Subject: Class II Permissive Change

FCC ID: BEJLC10SB
Date of Grant: 02/12/2016

We, LG Electronics Inc., apply for the C2PC change according with FCC Rule Part §2.1043.

#Change 2-2)
- Adding inductor on the line of the Antenna

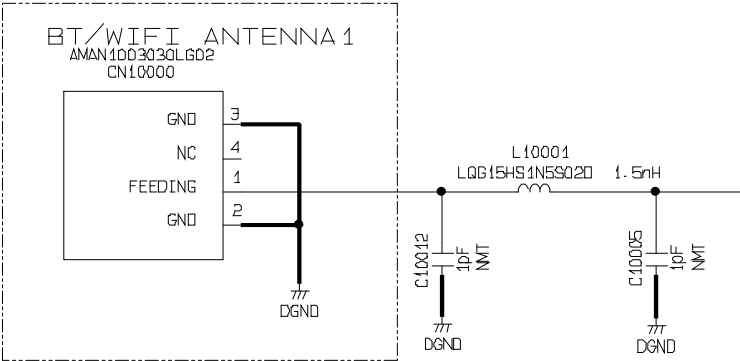
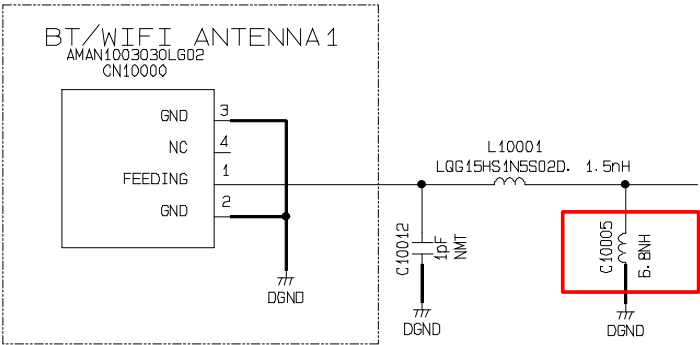
BEFORE				
ITEM	DESCRIPTION	LOCATION	MAKER P/NO	P/NO

AFTER				
ITEM	DESCRIPTION	LOCATION	MAKER P/NO	P/NO
Inductor	MLG1005S6N8J-TD25 6.8NH 5% - 600mA - - 0.25OHM	C10005	LG1005S6N8J-TD2	EAP62807113
